**AGENDA
CITY OF THE COLONY
PLANNING AND ZONING COMMISSION
JANUARY 27, 2015**

DRC -- January 22, 2015

RP14-0021

Replat -- Parkway Parcels, Lots 2R, 3X and 4, Block A

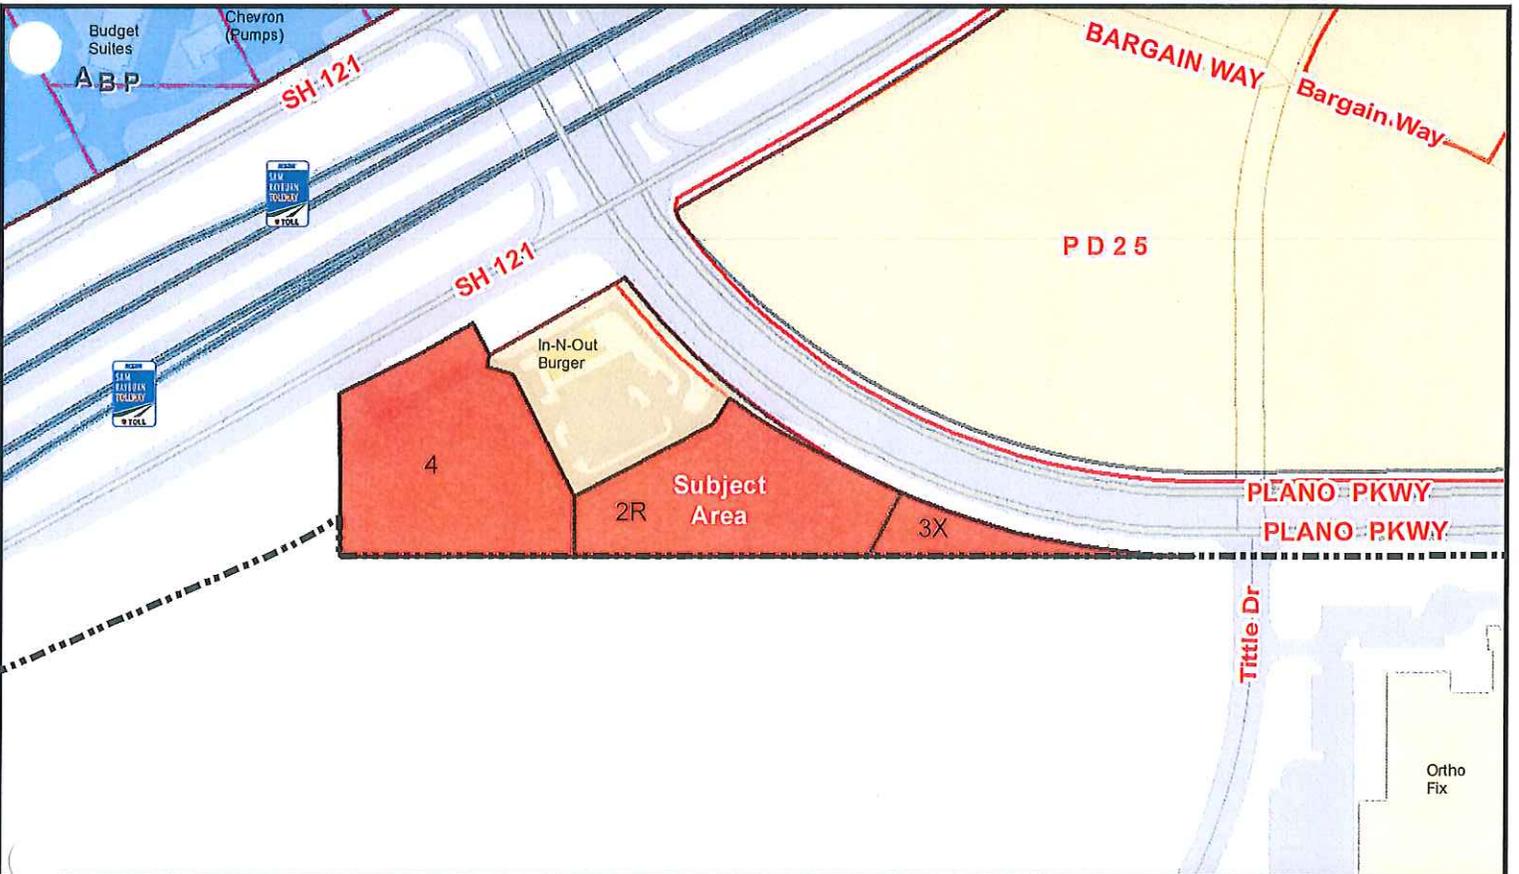
- EPW - 1. The drainage easement for storm drain boxes shall include a minimum of 8 feet clear on each side of the box.
- EPW - 2. The plat needs to have a private Channel Maintenance Language added for the open channel located on Lot 3 X, Block A. The language that should be added is attached for your use.
- EPW - 3. The Lot 4 Block A has the previous plat recordation property description still shown on the plat, please delete.
- EPW - 4. Remove existing and proposed label from all the easements on the re-plat. All the easements are per the re-plat.

- PL1. Add the file number to the Replat: FP14-0021
- PL2. Add the total acreage to the Title Block
- PL3. Change the dates on the replat to "2015"
- PL4. Provide a second State Plane coordinate on the plat
- PL5. If The Colony CDC is a current owner, please show this owner's address and contact number and provide a signature block.
